Staff Report

From: Colin Cortes, AICP, CNU-A, Senior Planner

Meeting Date: September 26, 2019 (Prepared September 19, 2019)

Item: 1800 W. Hayes Street “Nellie Muir Elementary School” (CU 2019-05)

1 LAYOUT AND PAVING PLAN - OVERALL
 1" = 40'

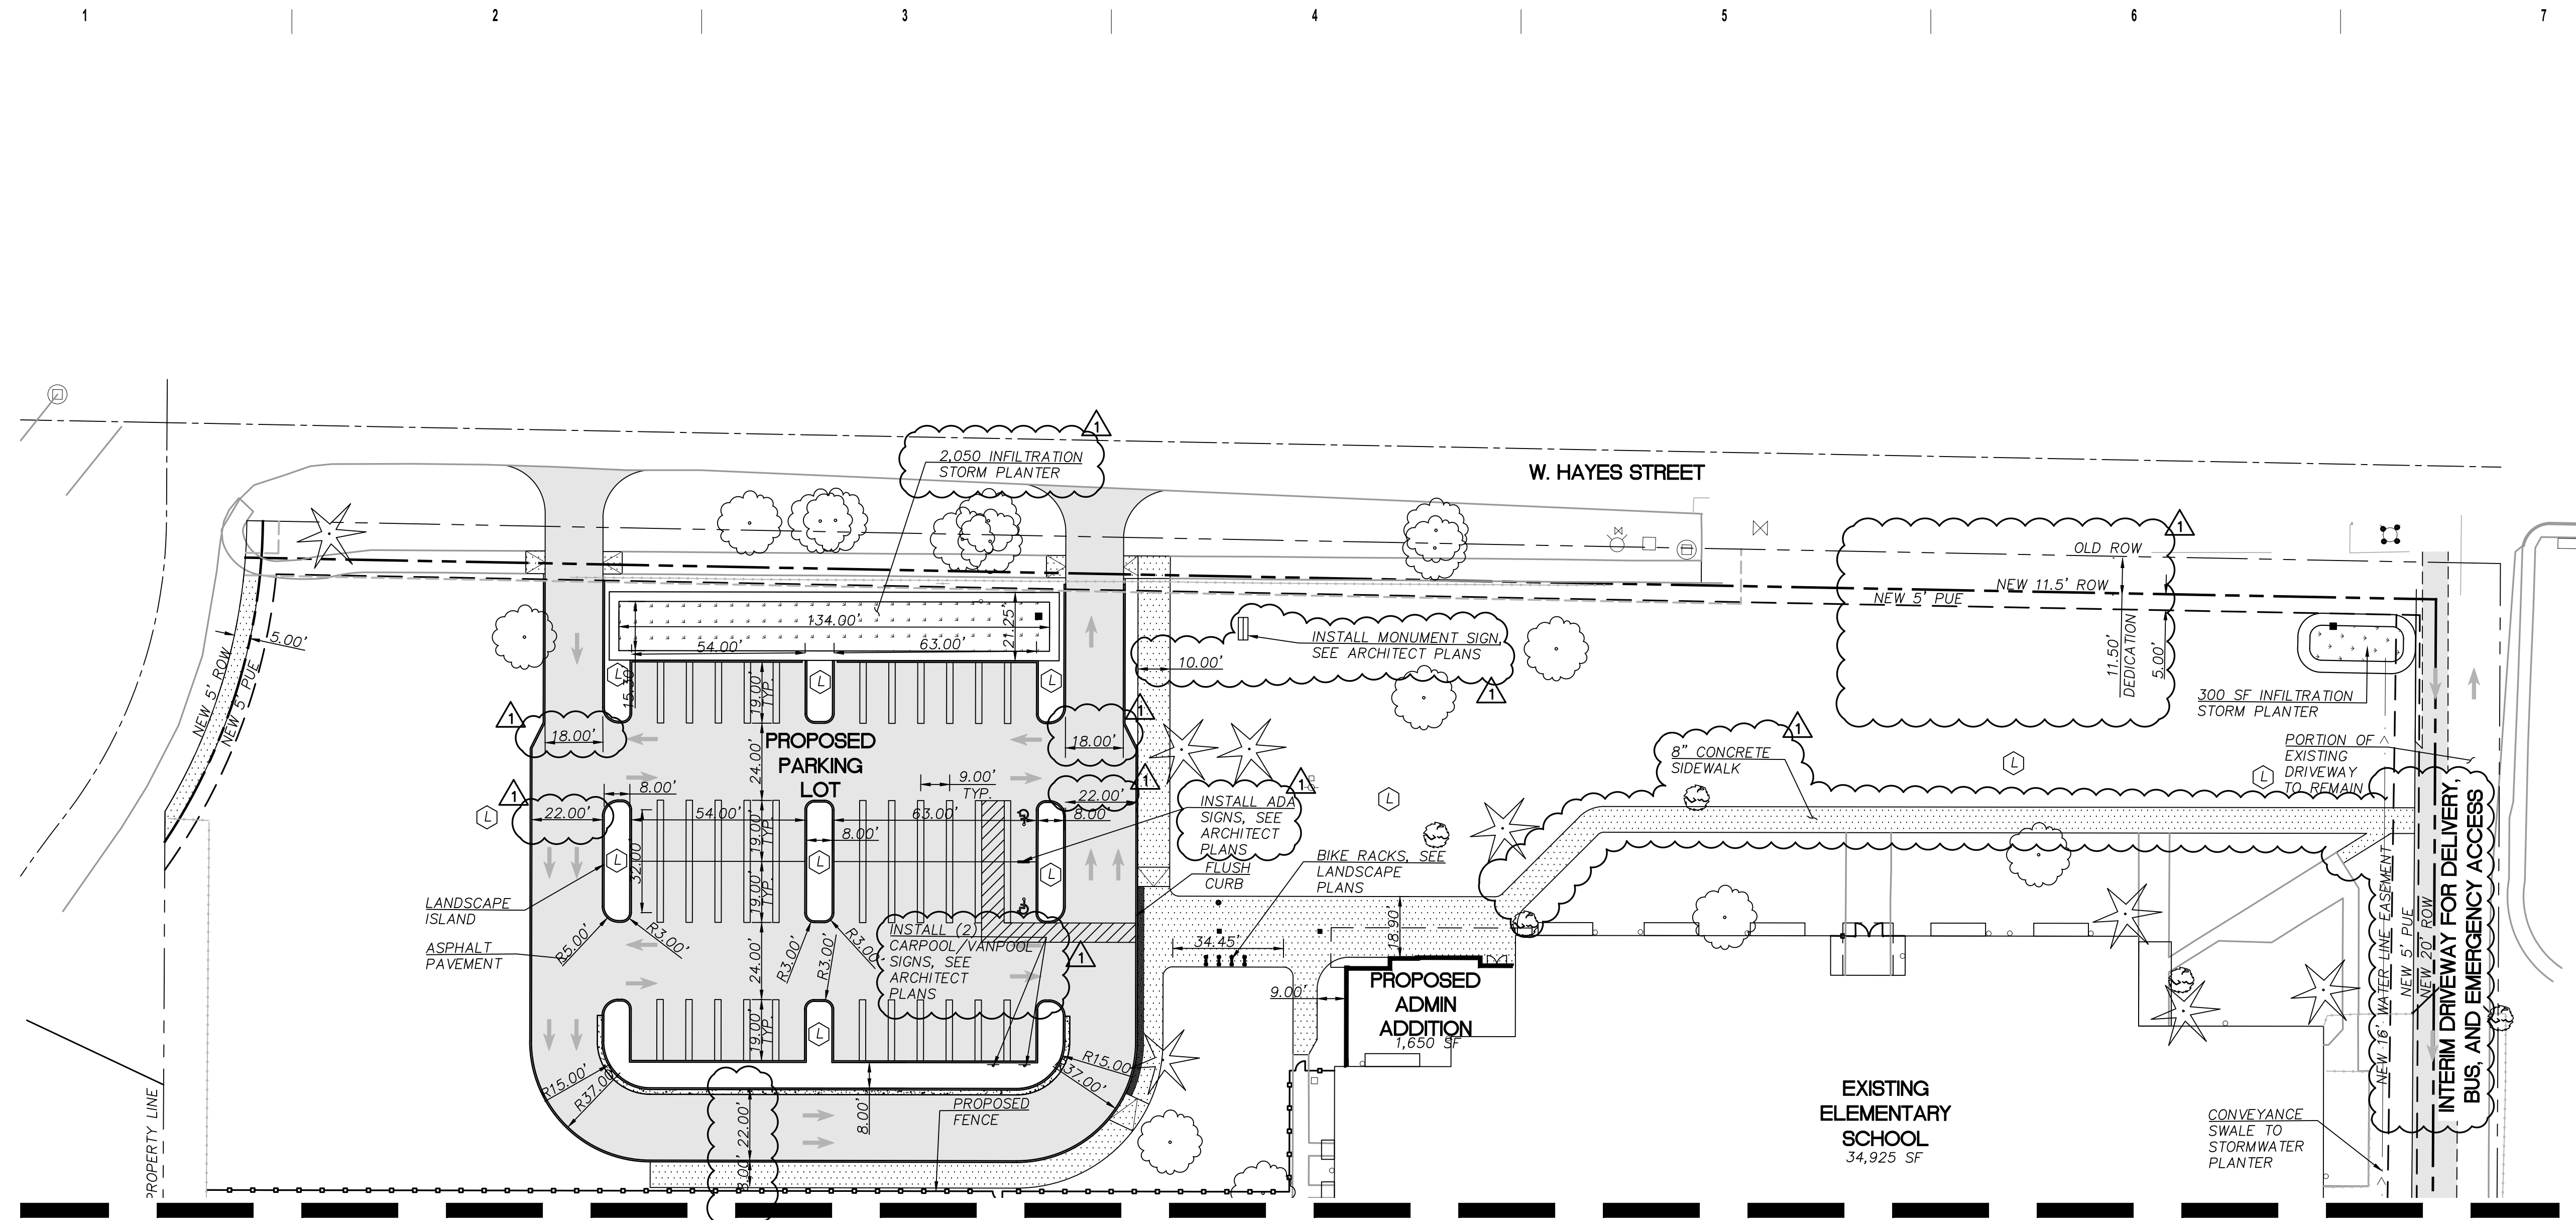
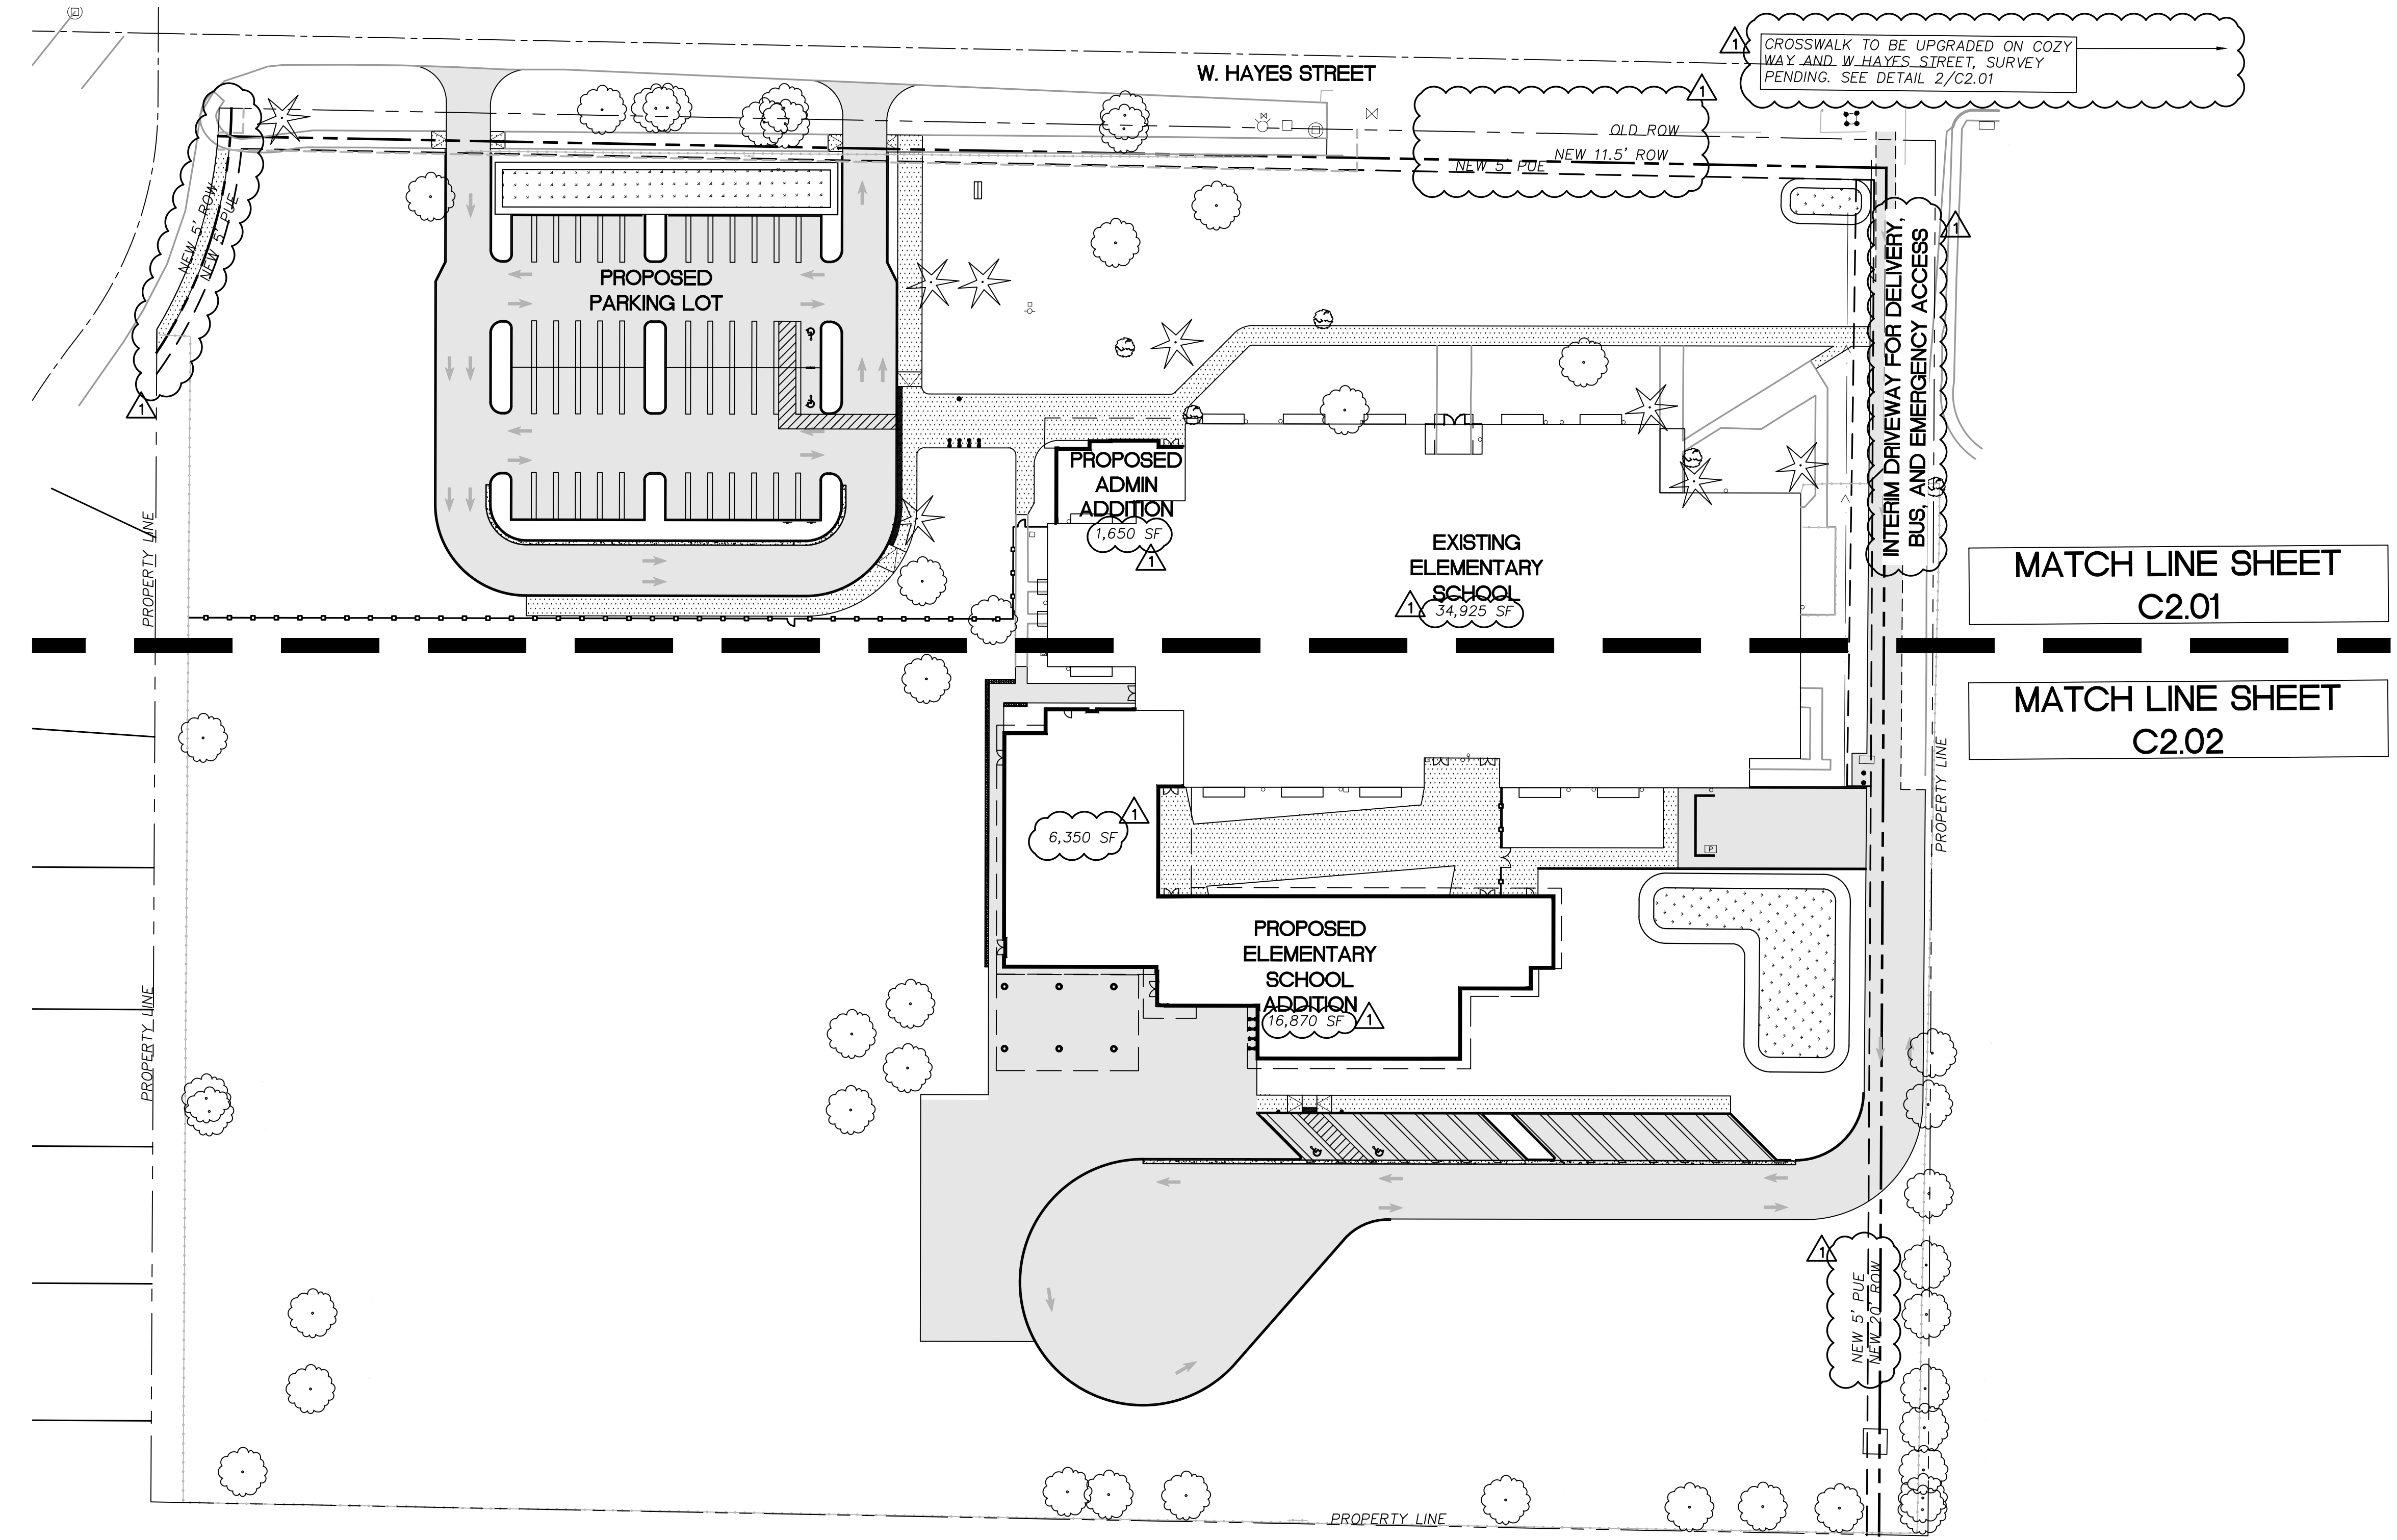
C8. Modular buildings / modulares: Consistent with the land use review plan set submitted August 23, 2019, Sheets C1.00 Existing Conditions and Demolition Plan and C2.00 Layout and Paving Plan Overall, the number of modular buildings shall go from four (4) to zero (0) and remain at zero. The removal of modular buildings is due by building permit final inspection. The City may later supersede this condition by taking action on a future land use application submittal as to allow one or more modular buildings.

A1.0

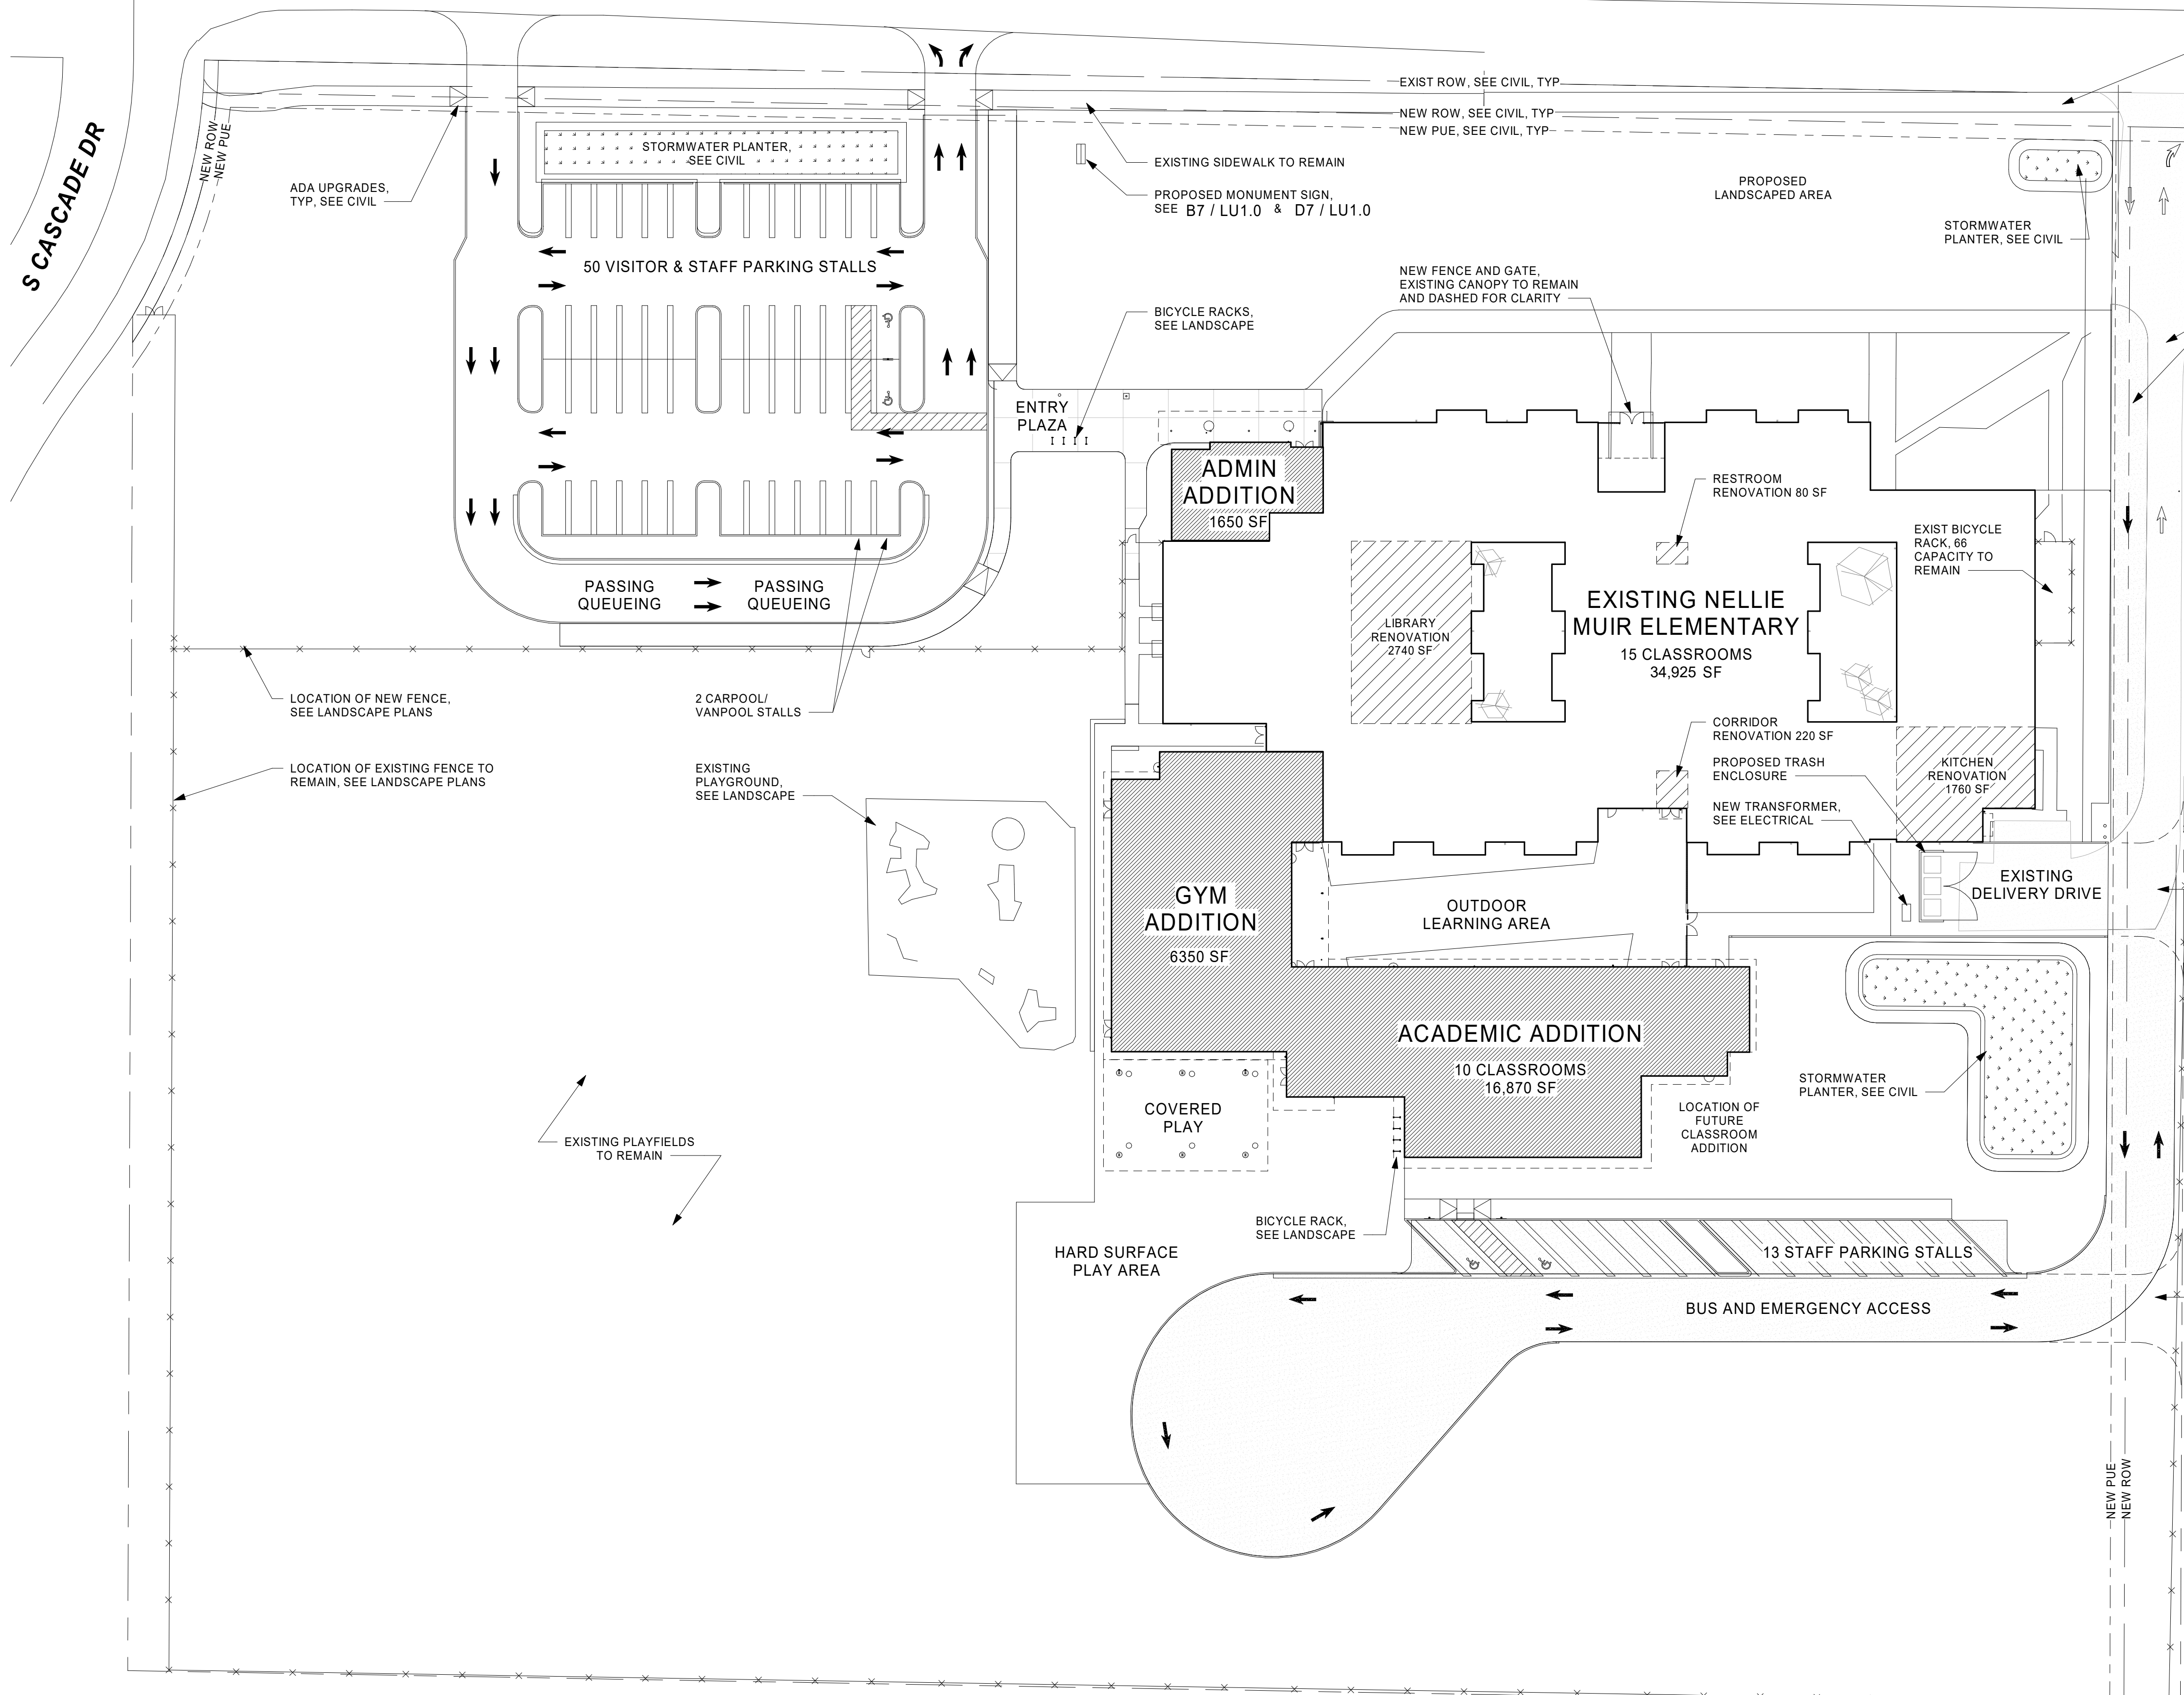
The site plans show directional markings, but not consistently. Staff defaults to what Sheet A1.0 shows, which is two arrows at each of the visitor east drive aisle and driveway indicating two distinct outbound lanes, hinting that the left lane is for left turns and the right lane for right turns.

▲ In order to clarify directional markings, staff applies *Condition D2*.

D2. Directional markings/stripping: To meet WDO 3.05.02J, the visitor parking area east one-way outbound drive aisle and driveway that are de facto two lanes shall each have two striped arrows in substantial conformance with Sheet A1.0.
